**ADDENDUM NO. 1
to the
Bid Documents
for
DPW Project #24253
UI Nez Perce Drive Improvements
Moscow, Idaho**

January 28, 2026

- Supplemental Information is attached:
 1. IDOPL Approved Plans, full set reissued, see attached.
 2. Grading plans with proposed contours showing, reissued, see attached.
 3. Revised Bid Proposal Form, see attached.
 4. Booster Pump detail CL-01, see attached.
 5. Joe Vandal Photo and Detail for mold development, see attached.

These plans are approved contingent on the compliance with the mark-ups and notes applied.

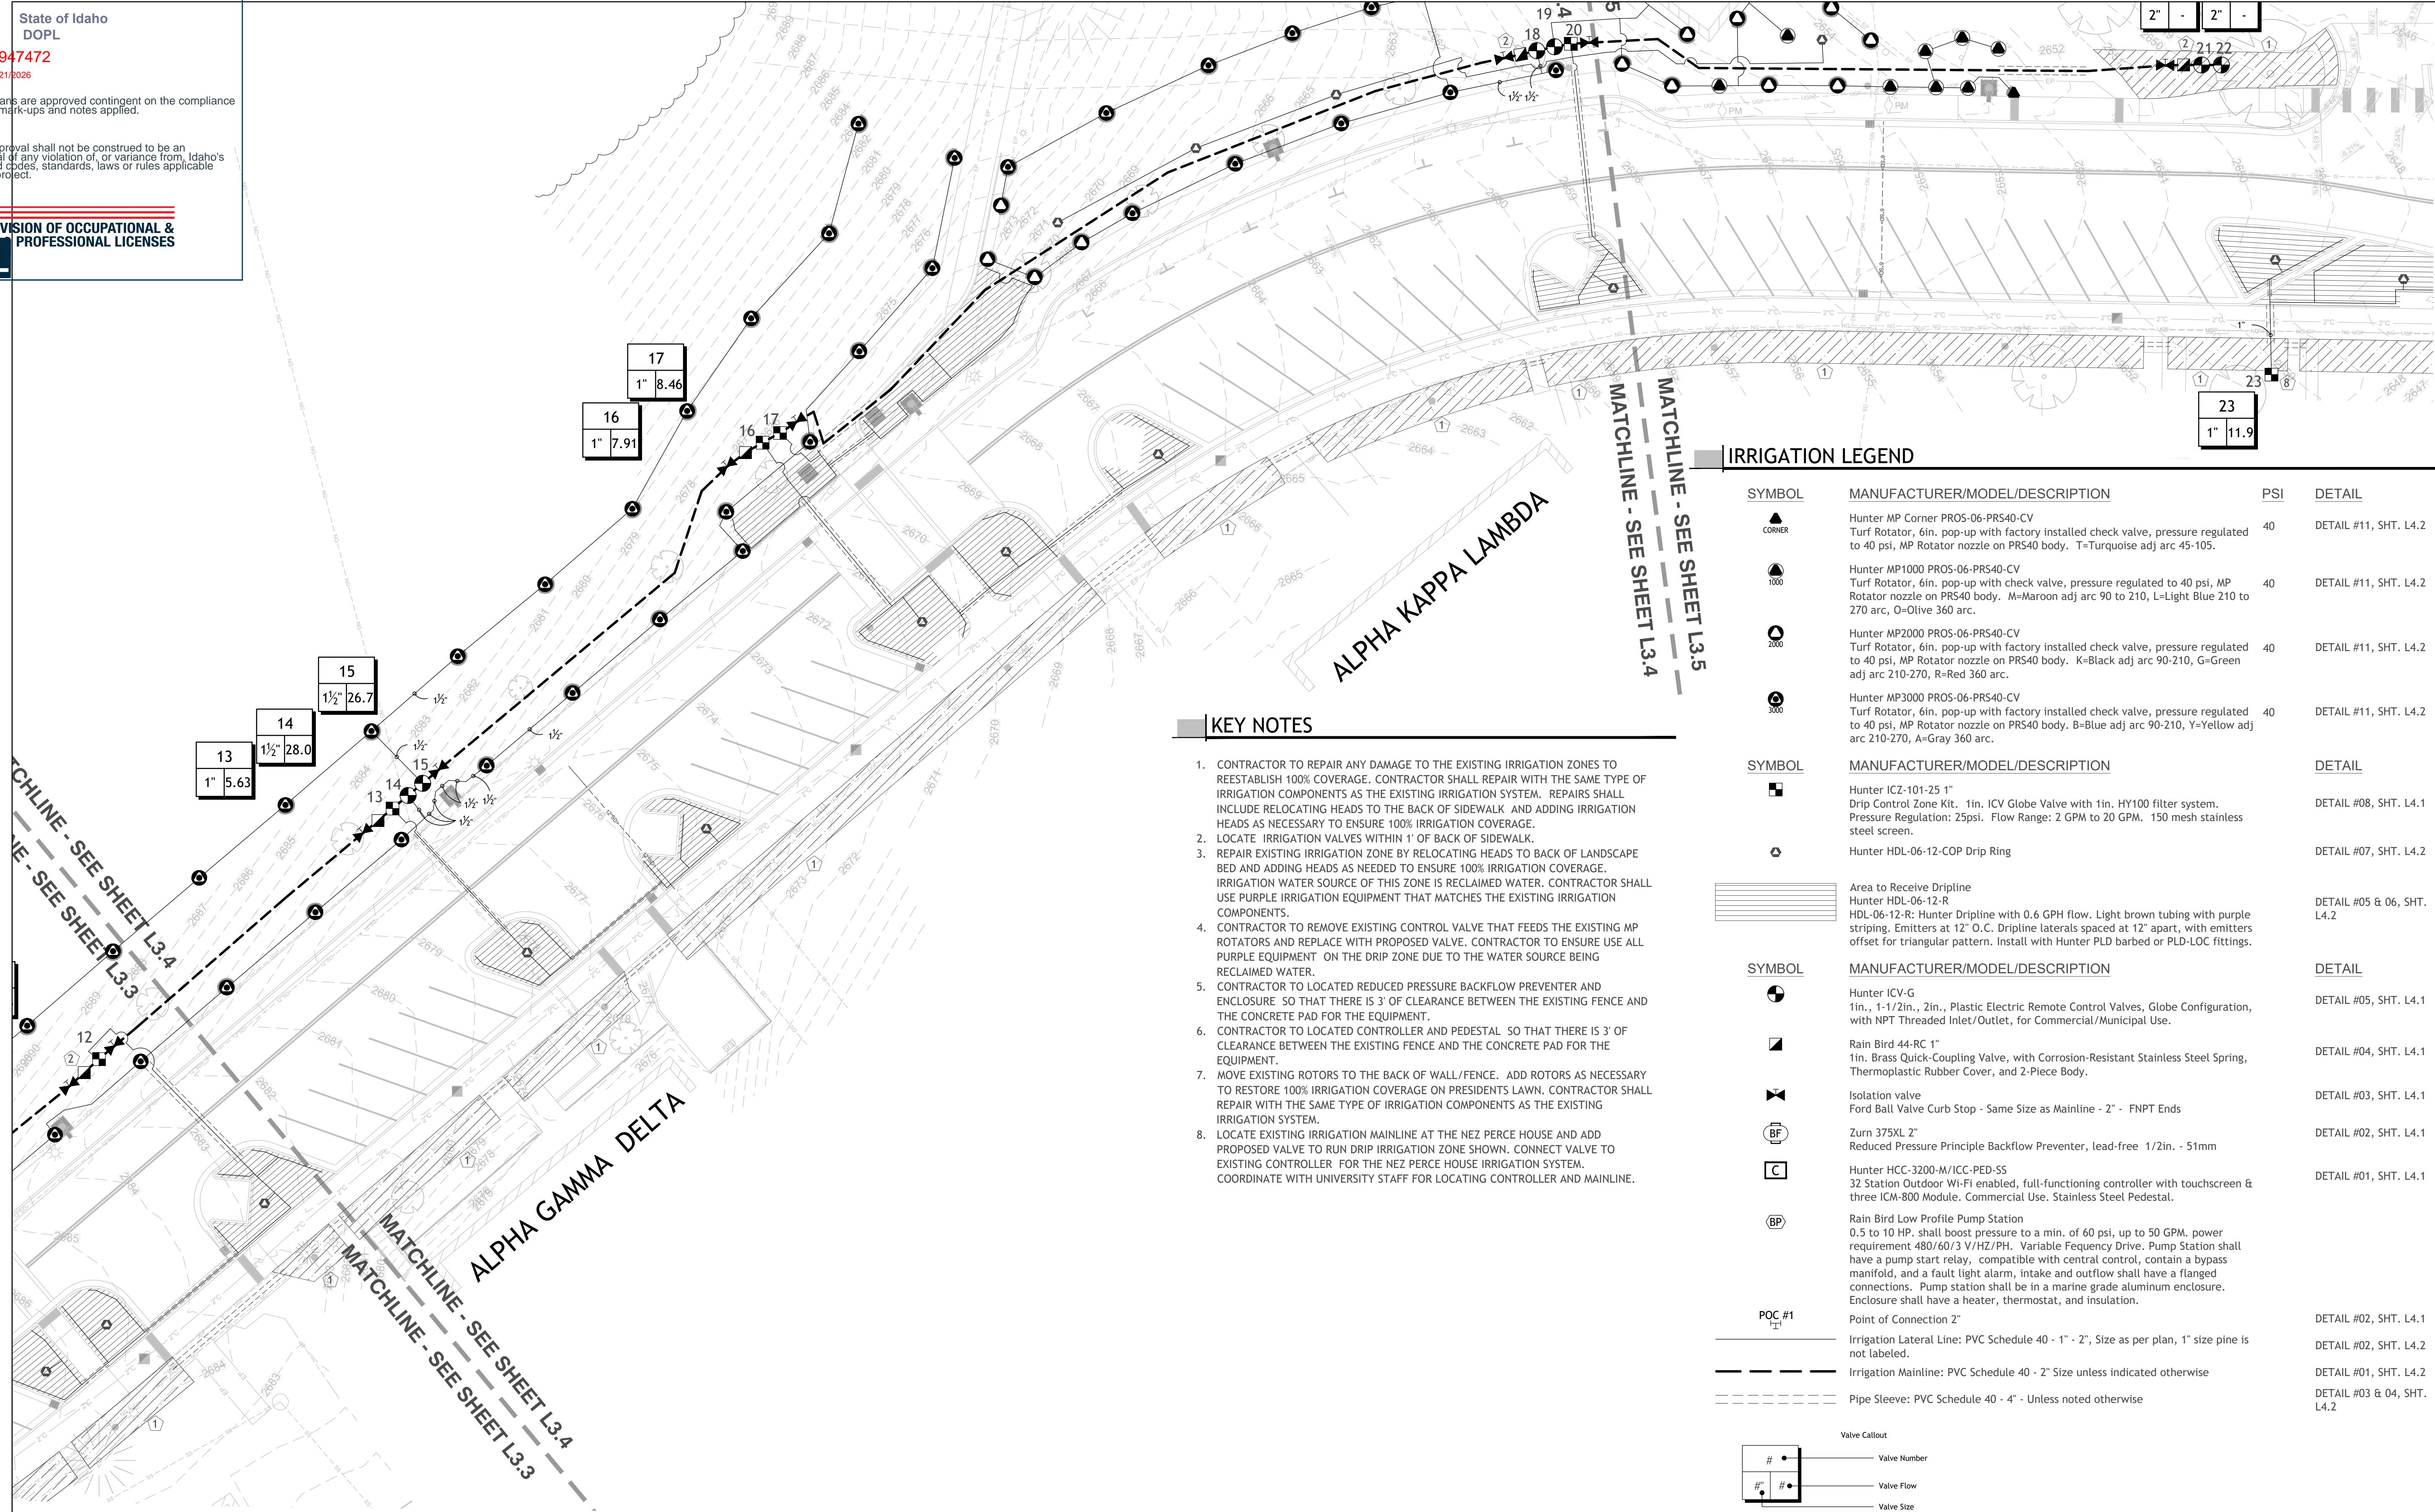
Irrigation Note #28: Revise: Revise note to read “All Irrigation Control Wire shall be 12 Gauge direct burial single conductor PE irrigation Wire. 2 Spare wires shall be installed throughout the entire irrigation system and be of a Unique Color (Orange).
2. REVISION: SHEET L3.0-L3.5

*Irrigation Legend Booster Pump: Revise: Revise to read
“Rainbird Compact Low Profile 3HP VFD Pump Station
3HP. Shall boost pressure 35 psi, up to 50 GPM. Power requirement 208V 60 HZ 3-phase.
Variable Frequency Drive. Pump Station Shall have a pump start relay, compatible with
central control, contain a bypass manifold, and a fault light alarm, intake and outflow shall
have either threaded or flanged connections. Pump station shall be in a marine grade
aluminum enclosure. Enclosure shall have a heater, thermostat, and insulation.”*

06 PRECAST CONCRETE PILASTER CAP DETAIL

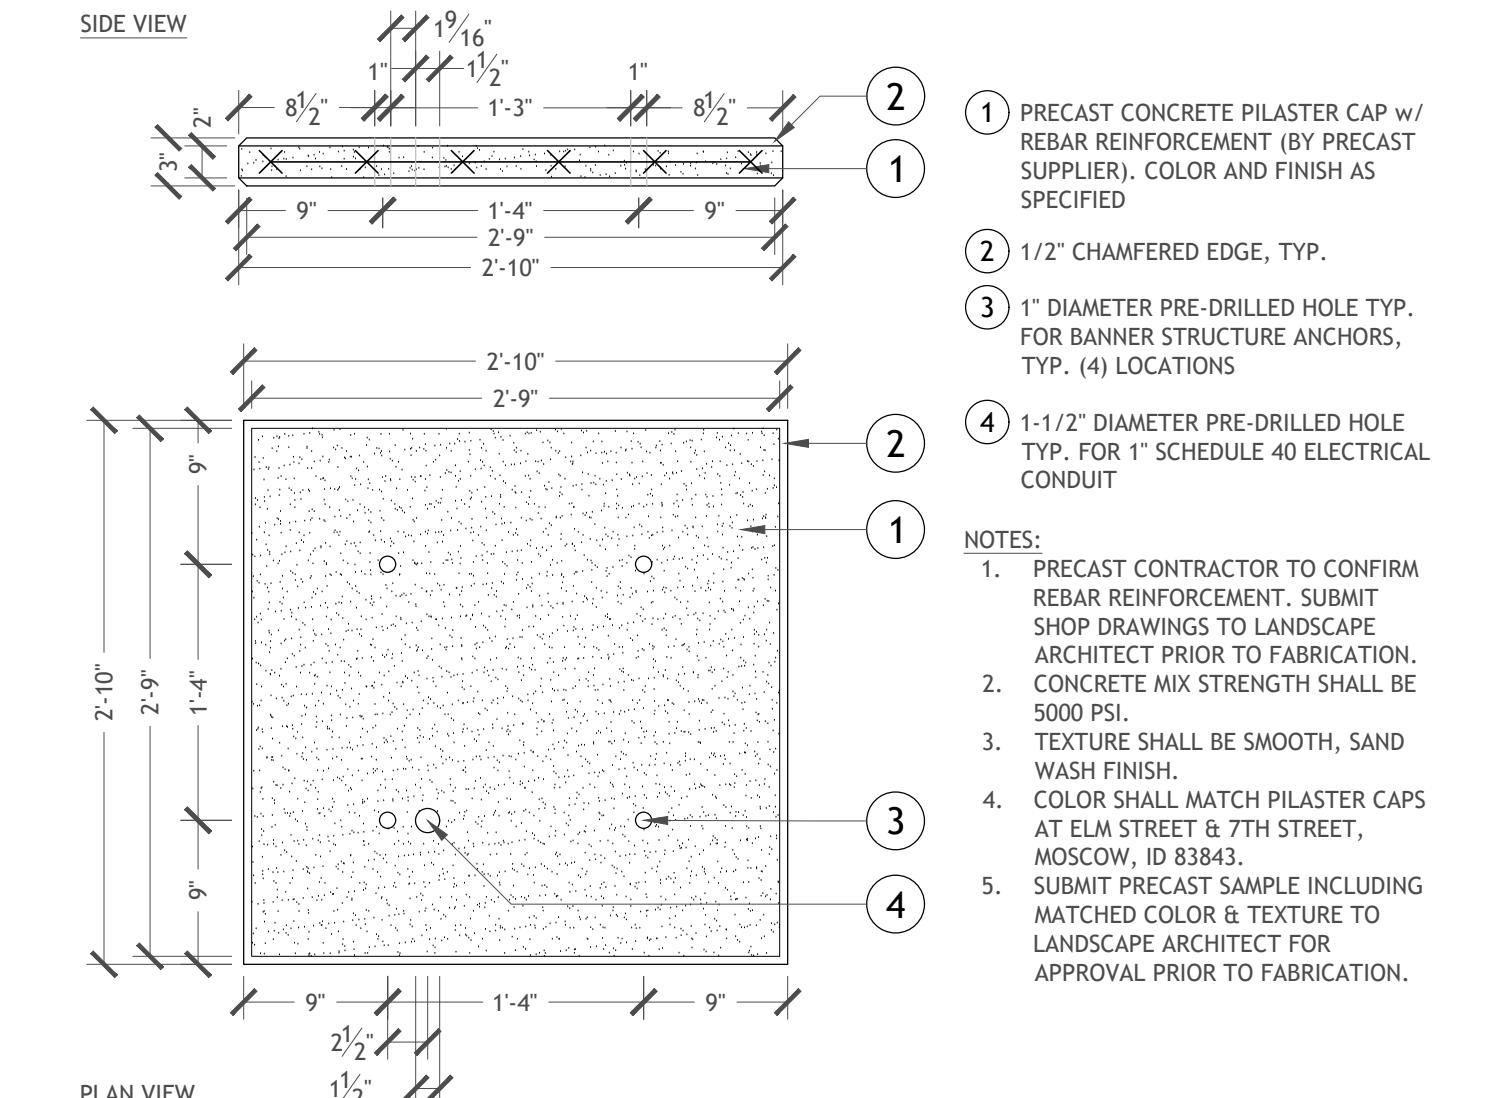
- Banner Pole – Detail 06
 - Note #01 says the Pilaster Cap is to be colored, then further states it needs to match caps at Elm St & 7th St.
 - Due to the short time line of the project, can this color be specified Pre Bid?

Answer #4: For the Note #1 Pilaster caps these shall be white concrete with “subtle” Davis Color “sandstone”, light sandwash to expose the marble aggregate. Talisman Construction Services, Inc., 509 487-1292, just did the pilaster caps at West Gateway Project and Campus Drive Ph 2. Other recent work on campus was by: Precast By Design Elk WA 509 292-2988, Innovative Concrete Products 509 315-5818. These pre-casters shall be considered pre-approved.

BOOSTER PUMP STATION

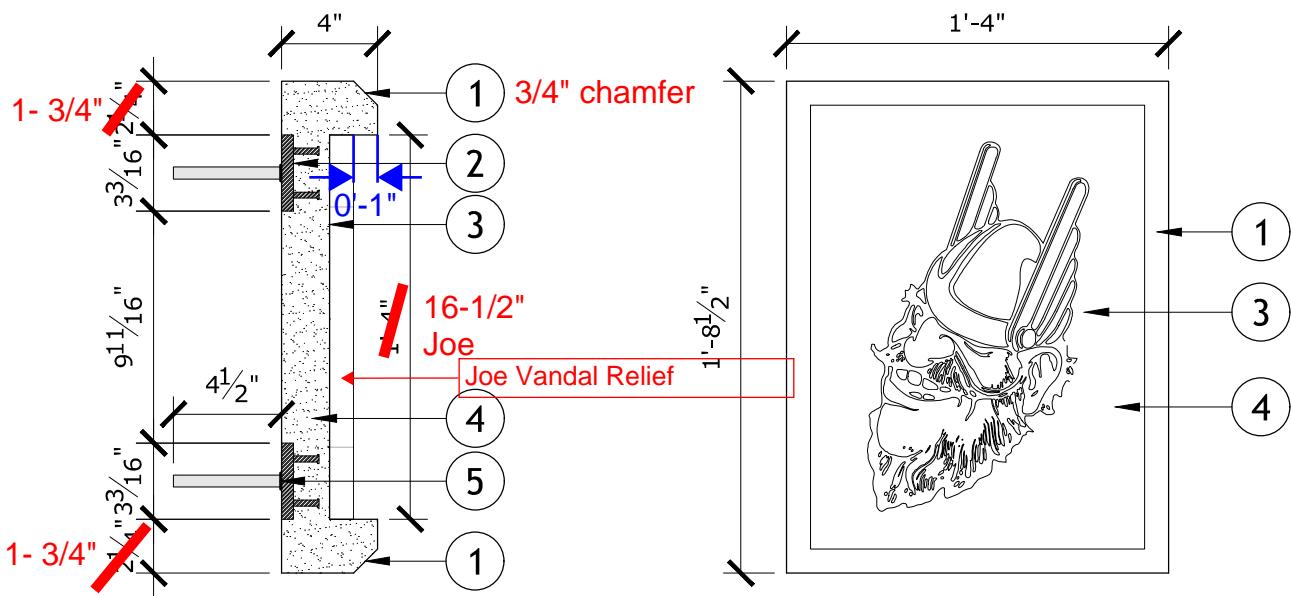
3. REVISION: SHEET L4.1
Add Booster Pump detail, see attached CL-01
